July 5, 2011

RE: CUYAHOGA COUNTY
CITY OF INDEPENDENCE
SELIG/ITC/BRECKSVILLE INTER.
CONSTRUCTION STORM WATER

On June 8, 2011, Ohio EPA conducted an inspection of the Selig Drive/ITC/Brecksville Road Intersection project located at Selig Drive and Brecksville Road intersection, City of Independence, Cuyahoga County. Ohio EPA records indicate that the site is covered by the General National Pollutant Discharge Elimination System (NPDES) Permit for Storm Water Associated with Construction Activity (General Storm Water Permit), permit No. 3GC05411*AG. I was accompanied by Don Ramm, Engineer during the inspection.

Figure 1. The sediment trap is filled with soil and rocks.

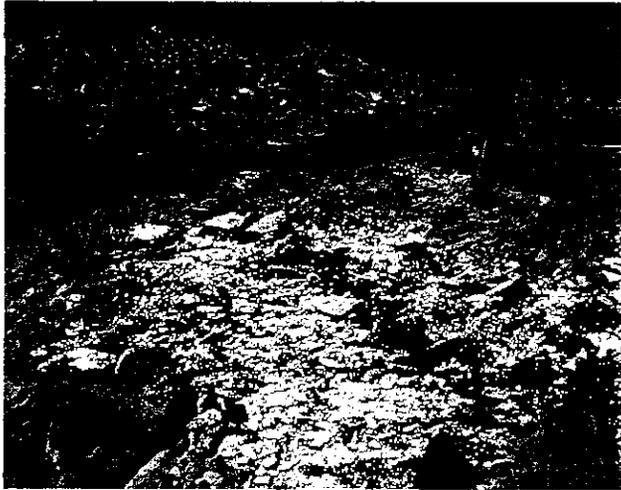
- The sediment trap located on site near the edge of Brecksville Road was completely filled in with soil and rocks. Please redesign the sediment trap per the specifications in the Storm Water Pollution Prevention Plan (SWP3) so that the trap can function properly (See Figure 1).
- The construction entrances are inadequate, resulting in a lot of offsite tracking of sediment onto Brecksville Road and the small side street off of Selig Drive. Please be sure to reconstruct these entrances according to the specifications in the SWP3, and remove the sediment from the streets using a street sweeper or some other appropriate method (See Figures 2 & 3).
